REPORT OF THE CHIEF OFFICER PLANNING AND REGULATORY

APPLICATION NO: P/2020 /0844	LOCATION: LAND OFF HIGH STREET JOHNSTOWN WREXHAM LL14 2BA	DATE RECEIVED: 07/12/2020
COMMUNITY: Rhosllanerchrugog	DESCRIPTION: DYMCHWEL YR ADEILADAU PRESENNOL A CHODI 10 ANNEDD / DEMOLITION OF EXISTING BUILDINGS AND ERECTION OF 10 DWELLINGS	CASE OFFICER: MP
WARD: Johnstown	APPLICANT(S) NAME: MR MICHAEL FORGRAVE	AGENT NAME: PARRY DAVIES ARCHITECTS LTD MR RICHARD GRATTON

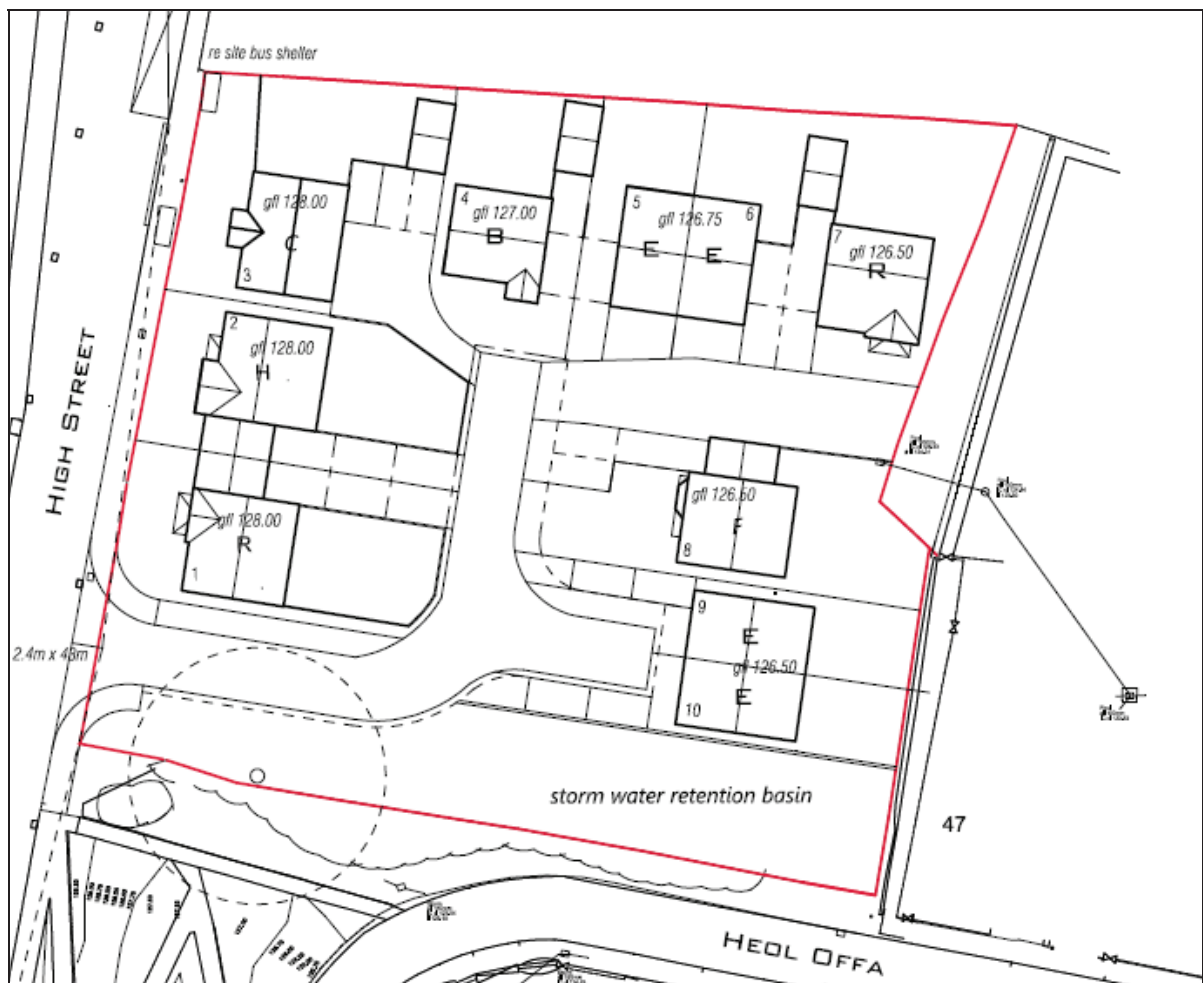
The current proposed layout requires the removal of an ash tree (T1) which is subject to Tree Preservation Order WCBC 108. This a tree of significant amenity value with a TPO fully warranted and justified.

From the guidance provided on both TPO's and ADB I would consider the most appropriate actions regarding the ash (T1) would be to retain and pollard the tree to a height of approximately 4.0m with a monitoring programme then set in place.

Should any further change in the trees condition justify its removal then a replacement tree of large, maturing stature can be located upon the same area of land thus ensuring continued amenity.

The current layout should be amended to ensure the ash tree and its estimated root protection area (RPA) is retained and appropriately protected from development and future conflict. An arboricultural method statement would be required subject to condition.

Applicant Submissions: The applicant has submitted an amended plan site layout plan in response to the above comments. The principal amendments are:

- Revised access position;
- Plots 1, 2 and 3 repositioned further to the north;
- Removal of the sub-station in the north-west corner of the site – this no longer being required by the utilities undertaker;
- Change to the house types used on plots 4, 7 and 8. The changes the house type mix to 4 x 2 bedroom, 1 x 3 bedroom and 5 x 4 bedroom dwellings.

The amended site plan is included below:

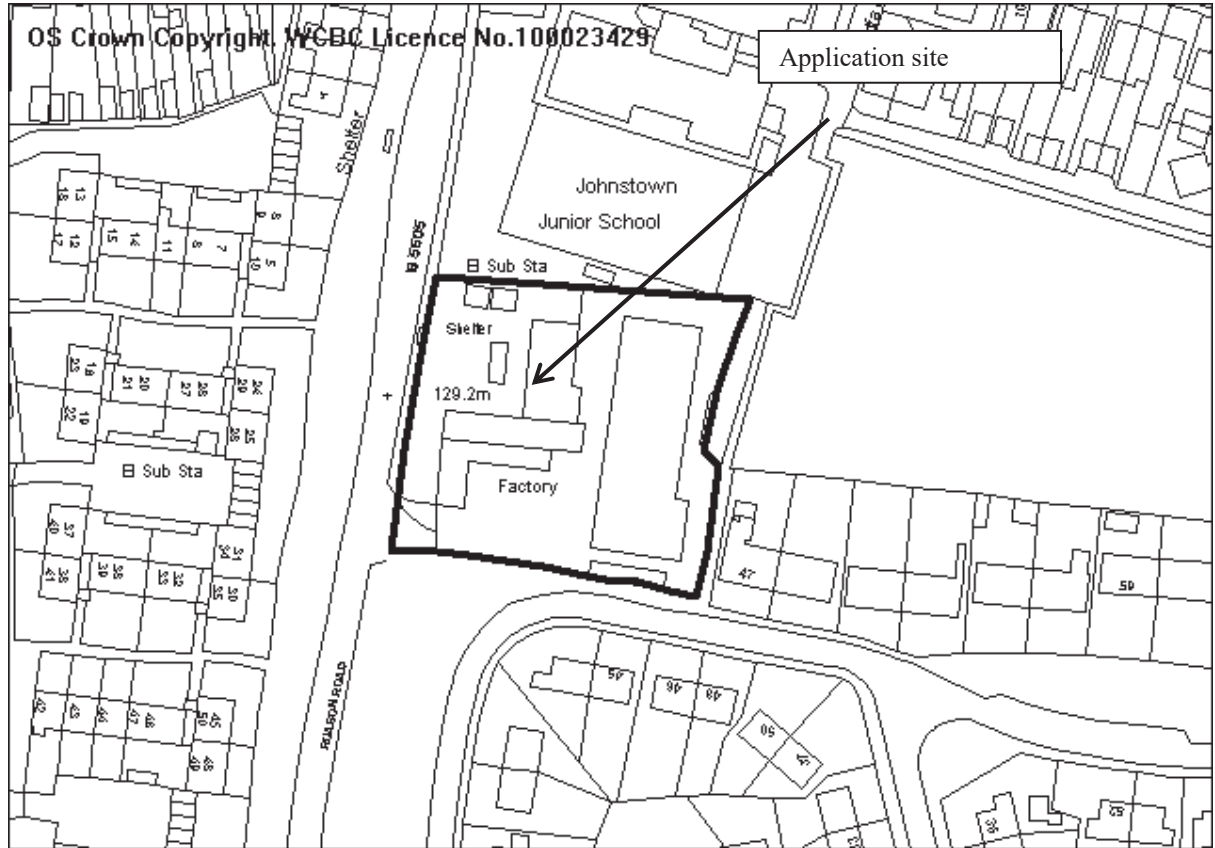
The amended site layout is acceptable in design terms, retaining a strong built frontage to both High Street and within the development. The revised plot 8 will be approximately 1.2m higher than plot 7 and 0.8 higher plots 5, 6, 9 and 10 owing to the incorporation of a room in the roof space. This room will be served by a north facing window and a west facing dormer. The difference in roof height will not detract from the character of the development given that a mix of house types is provided. The plots to the front (west) of the site will also be built on higher ground, so there will be a relative difference in height across the site in any case.

The distance from the north elevation of plot 8 to the front elevations of plots 6 and 7 is 12 metres and 14 metres respectively. Whilst this is less than the 22 metres recommended by LPGN21, I do not consider this arrangement will unduly compromise the standard of privacy afforded to the occupiers of the latter 2 plots. Both plots face plot.8 over a shared driveway where a degree of overlooking will occur from passing vehicles and pedestrians irrespective of the proposed side facing window. The relative positions of the plots is such that I am satisfied the standard of amenity afforded to the occupiers of plots 6 and 7 will not be compromised by way of loss of light or by plot 8 being visually overbearing.

Design and Amenity: The amendment will enable the Ash tree to be retained. An Arboricultural Method Statement has also been submitted setting out how the tree will be protected during construction.
